Kings College Court, 55 Primrose Hill Road, London, NW3 3EA

SUBJECT OF APPEAL

Appeal against the refusal of details (synthetic Sto-brick slip material) submitted under application reference 2016/0070/P in relation to the discharge of condition 4 (external finishes) of planning permission reference 2013/6388/P dated 19/06/2014 for:

Drawing Title
 Hughes Parry Tower
 Brick Set-Out
 Typical Section Details

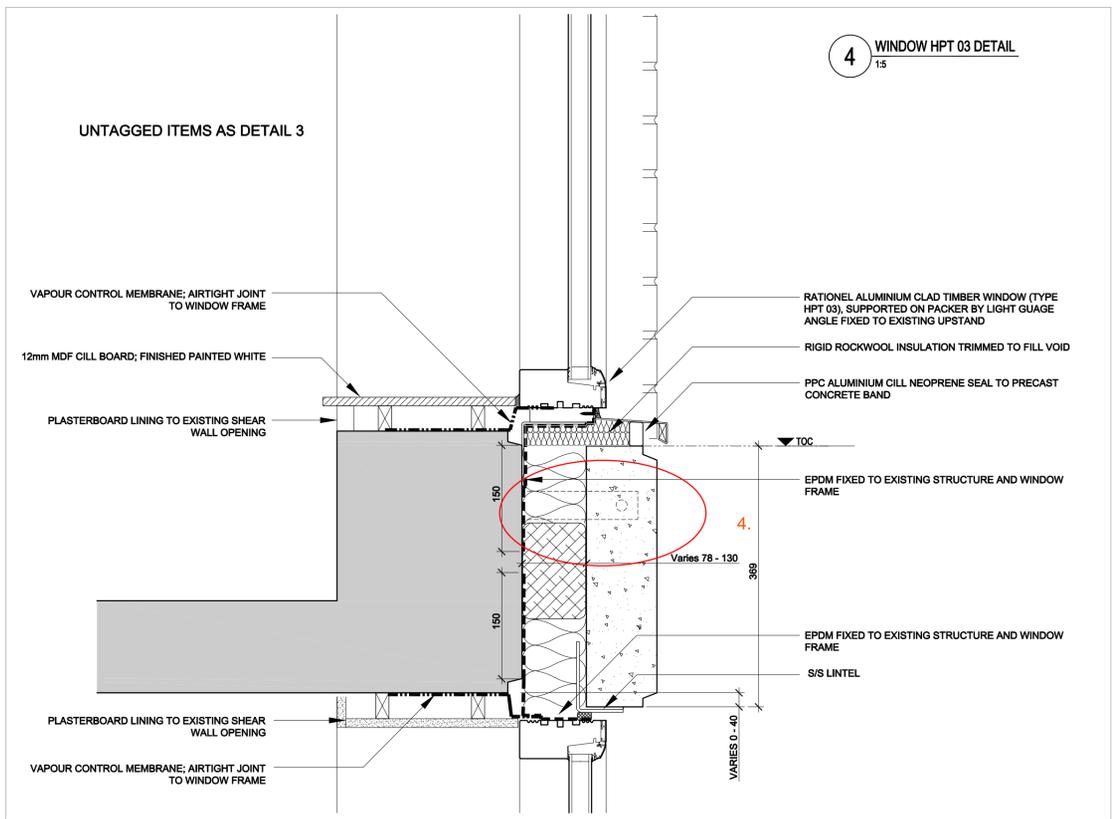
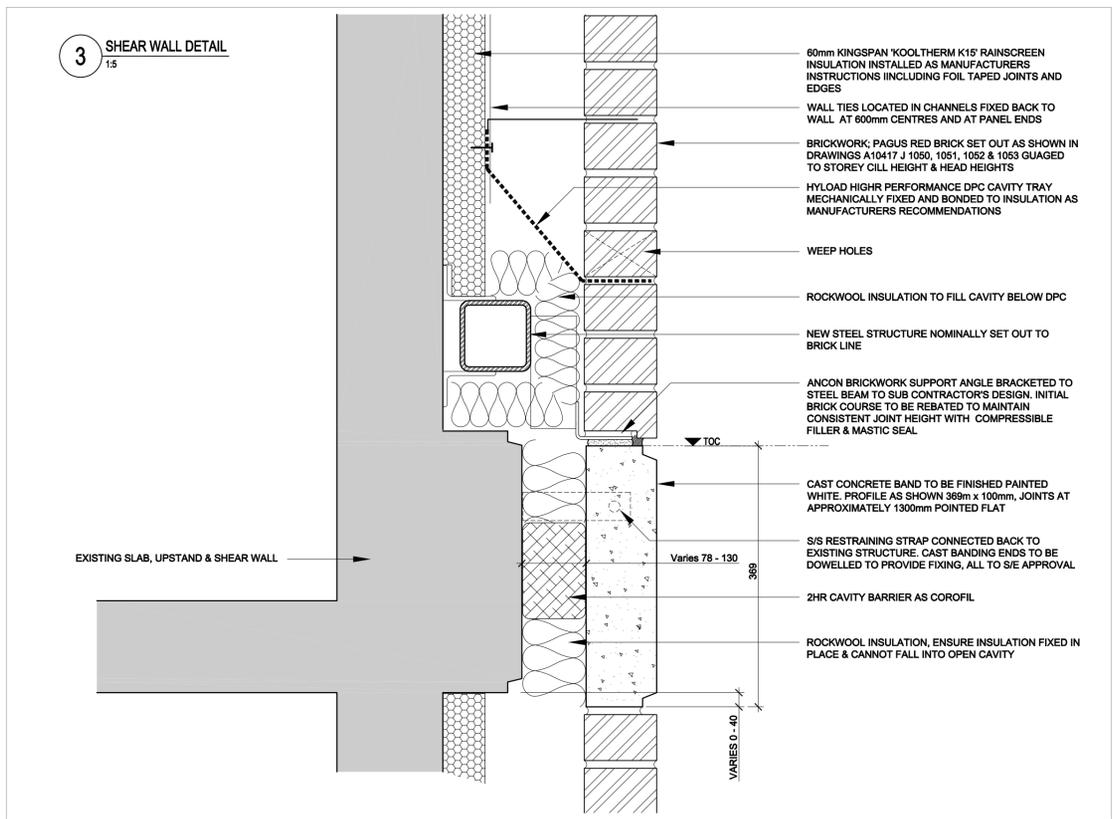
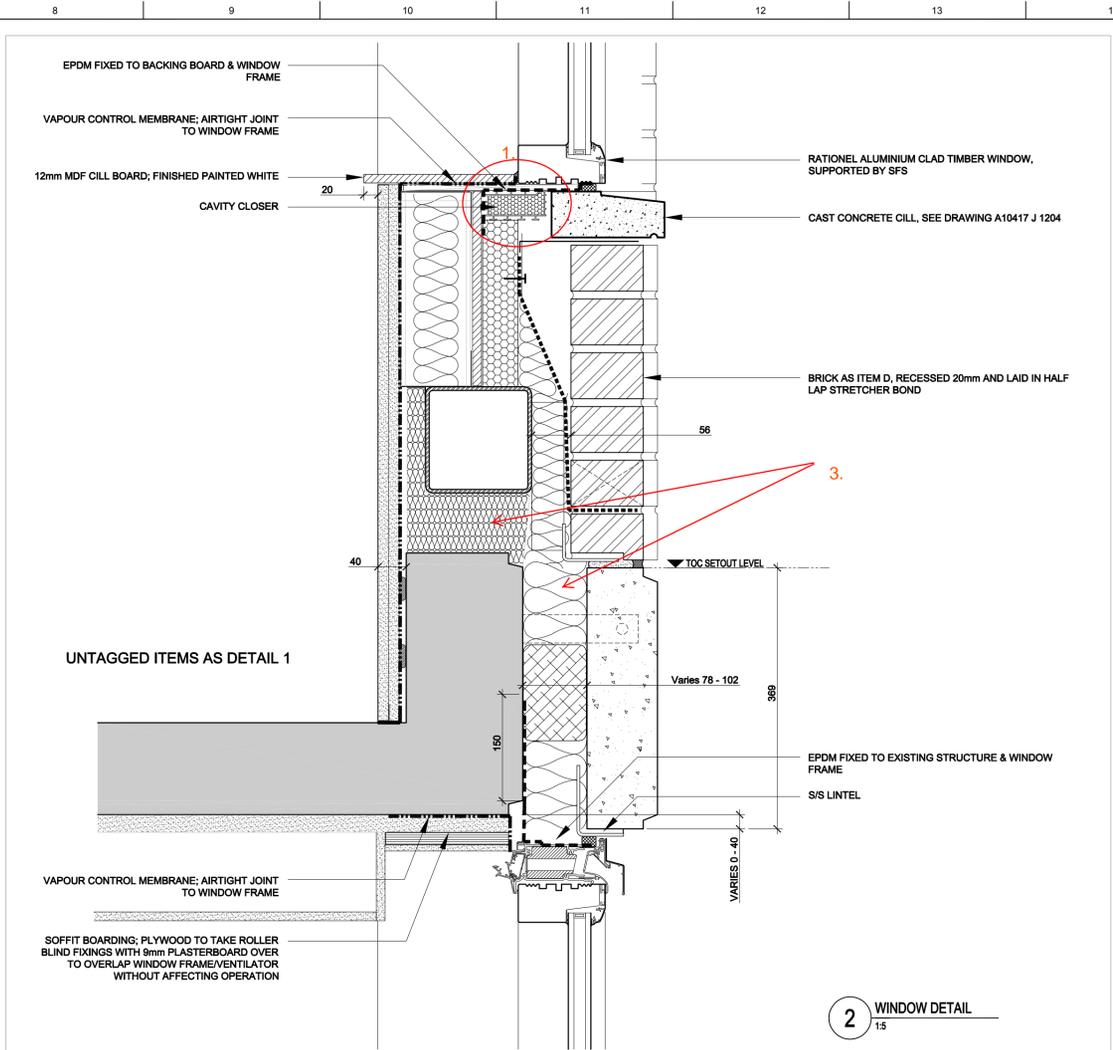
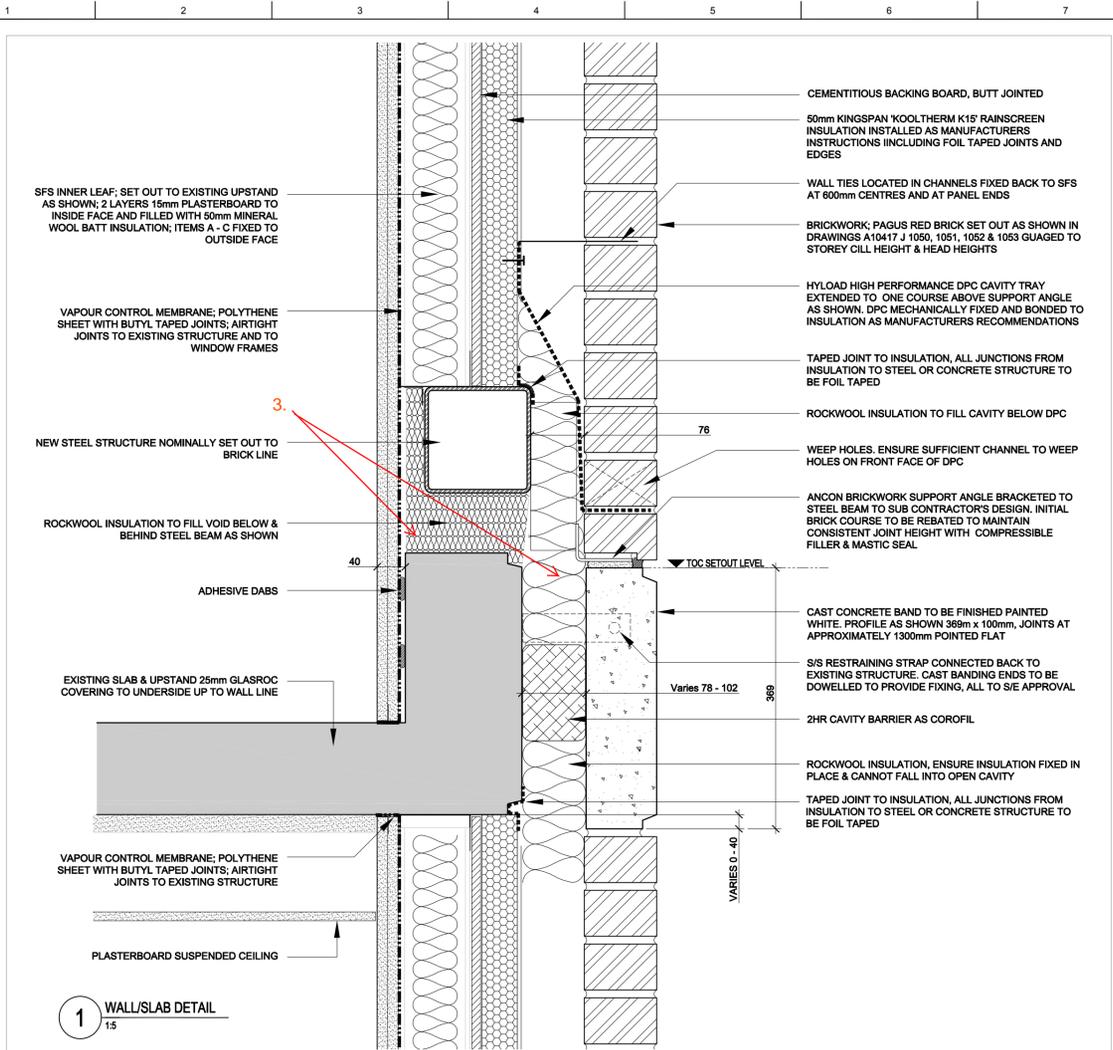
BMCE Comments 27/08/15:
 1. Cavity closer agreed at rigid K15 Rainscreen insulation with DPC at insulation and reveal interface.
 2. Refer to S7000 Series drawings for vertical cavity barrier fire barrier locations.
 3. These insulation types have been agreed as soft mineral insulation and are in fact the same insulation type.
 4. LM advise that stone band restraint fixing can be fixed to avoid the window EPDM.
 5. PC stone pieces are 75mm thick with exception being at the staircases where the stone bands are 85mm thick.
 6. TPB to confirm stone band setting out, confirming location of stone band cuts.
